## Post-installation Review

**NYSERDA PON#: 2456**

**Applicant: New York Times**

**Project: Treatment of Air Cooled  
Condensing Units**

Figure 21 ACU-10, EER vs. Outside Drybulb

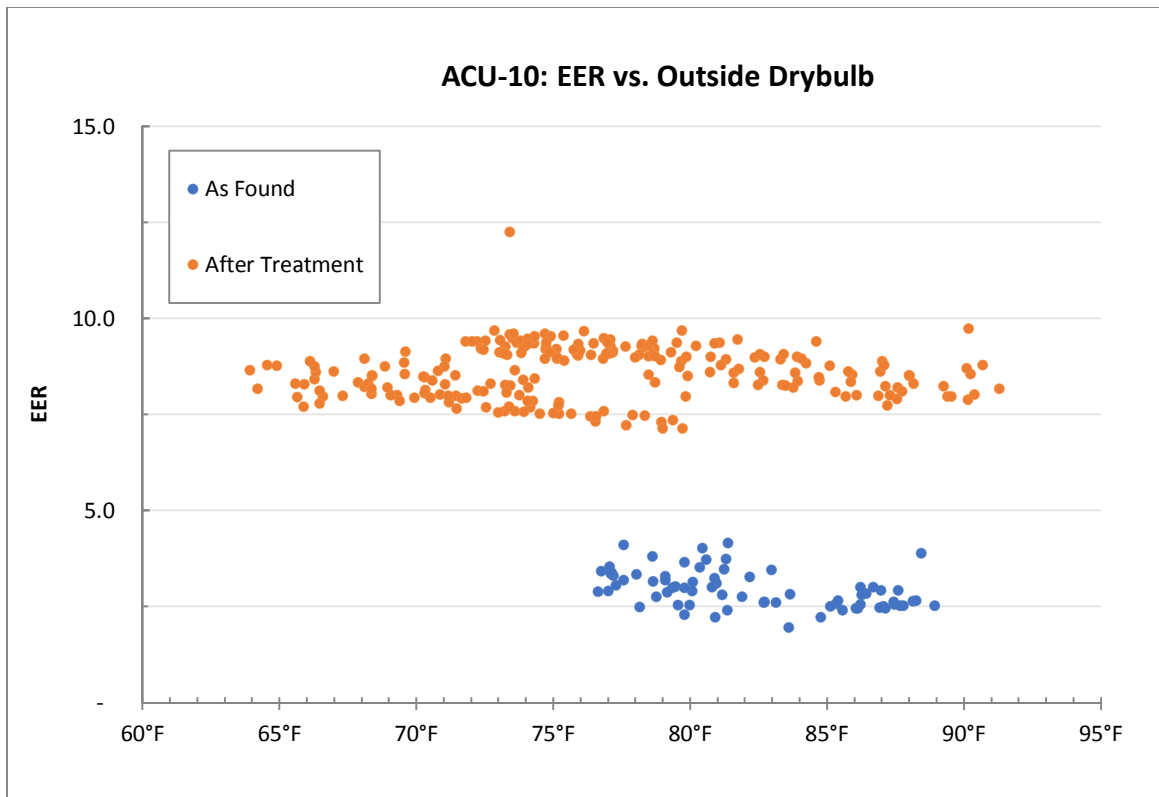
The following figure presents a plot of EER as a function of outside drybulb temperature for the existing and proposed cases. As observed below, the efficiency of the unit is significantly improved from approximately 2.9 EER in the existing case to 8.6 EER in the proposed case.

Overall, the results were problematic and savings appeared to be aggressive

- For two of the units, the calculated EER is extremely low (2.9 to 3.5 EER). Applying this to all units may result in exaggerated savings.
- The analysis uses weather to estimate existing consumption for three units. However, a utility bill analysis was not performed to estimate existing cooling consumption for the facility.

Figure 23 ACU-11, EER vs. Outside Drybulb

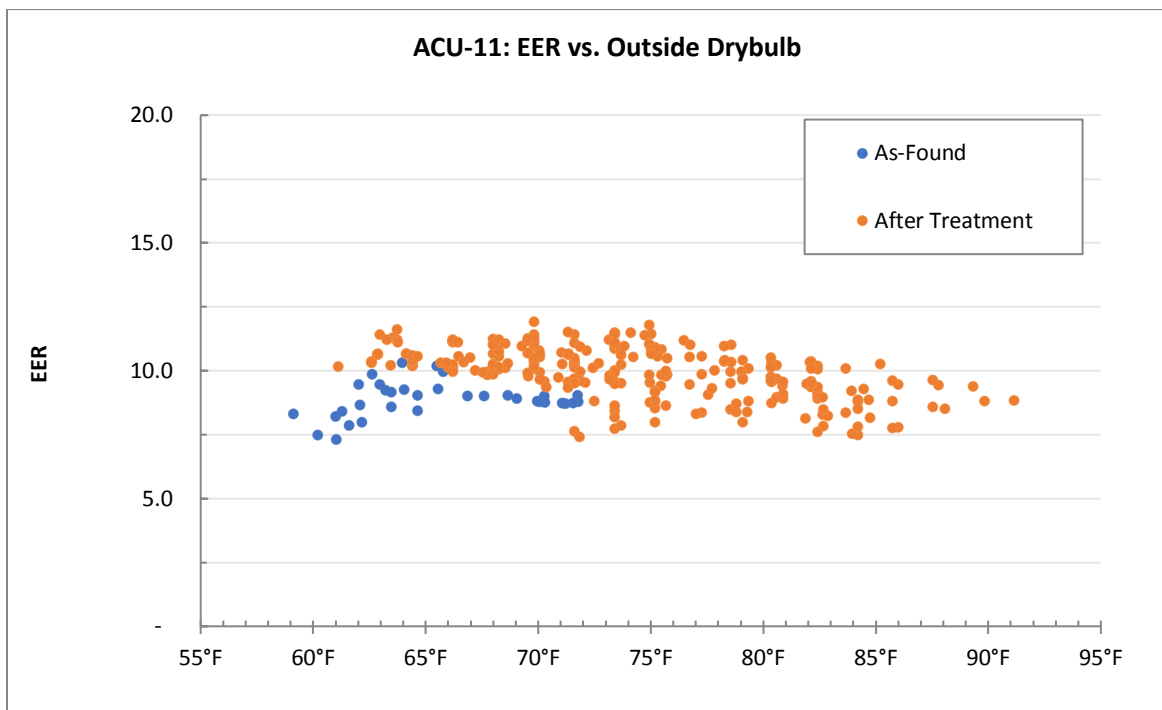
The following figure presents a plot of EER as a function of outside drybulb temperature for the existing and proposed cases. As observed below, the efficiency of the unit is slightly improved from approximately 9.7 EER in the existing case to 10.0 EER in the proposed case.

- As with many O&M projects, there is no consistency in savings. For example, ACU-11 saves 59 kWh/ton per ton while ACU-14 saves 4,879 kWh/ton based on the data provided.

Figure 25 ACU-14, EER vs. Outside Drybulb

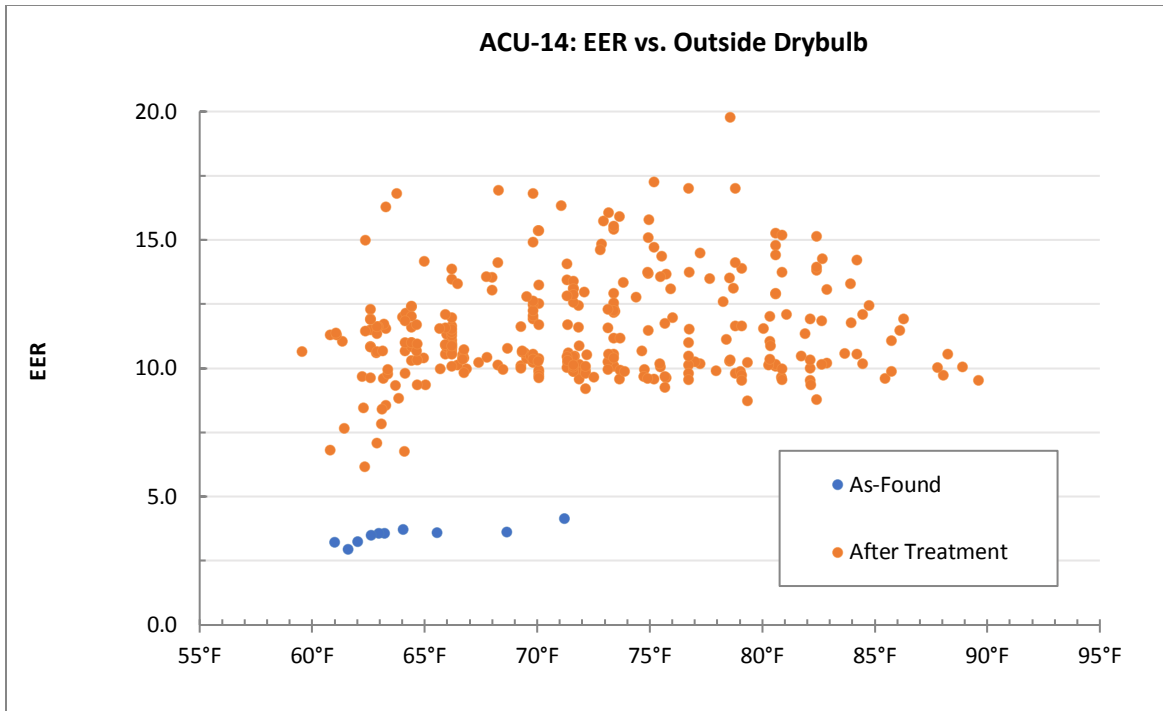
The following figure presents a plot of EER as a function of outside drybulb temperature for the existing and proposed cases. As observed below, the efficiency of the unit is significantly improved from approximately 3.5 EER in the existing case to 11.5 EER in the proposed case.

Table 5 New York Times Annual Utility Consumption

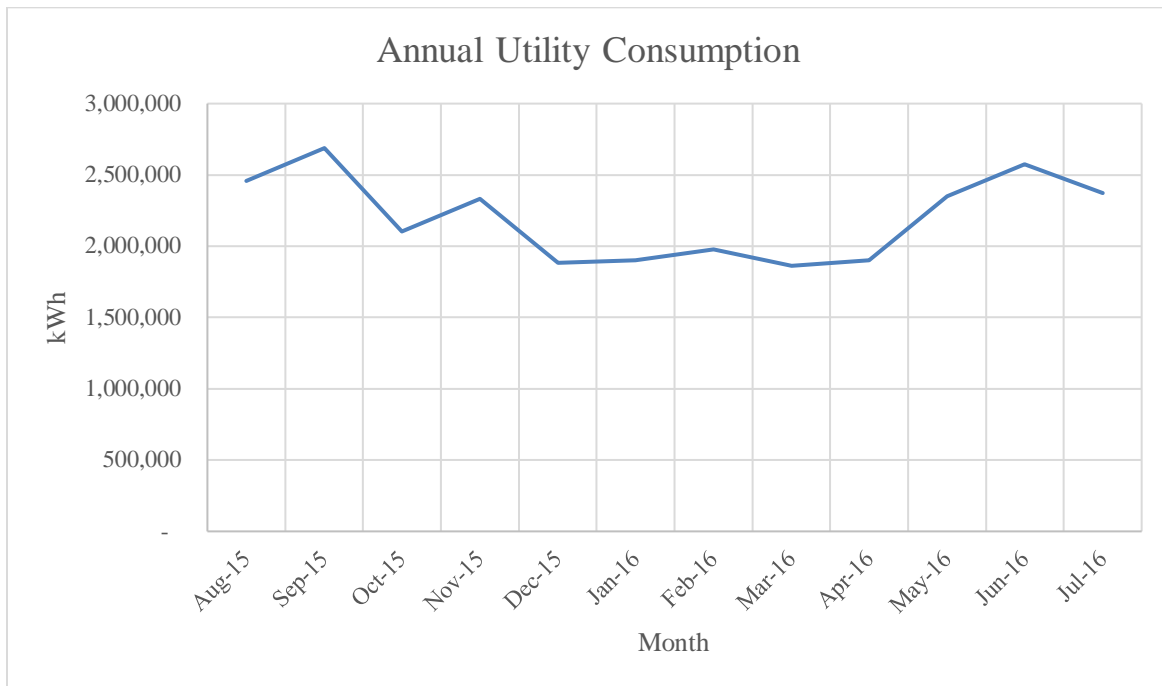
TRC collected one year of utility bills to review the utility spend for the facility. The average baseload during this period was approximately 1,900,000 kWh. TRC then estimated the consumption from May through September that was associated with cooling. During this period, approximately 2,500,000 kWh was associated with cooling. 2015 and 2016 were much hotter than the typical area. Therefore, cooling consumption was weather normalized and adjusted lower to reflect typical year consumption. TRC assumed that weather-normalized cooling consumption is proportional to cooling degree days. As a result, weather-normalized cooling consumption is estimated to be 1,900,000 kWh.

The weather-normalized cooling consumption of 1,900,000 kWh was used to establish the baseline cooling consumption.
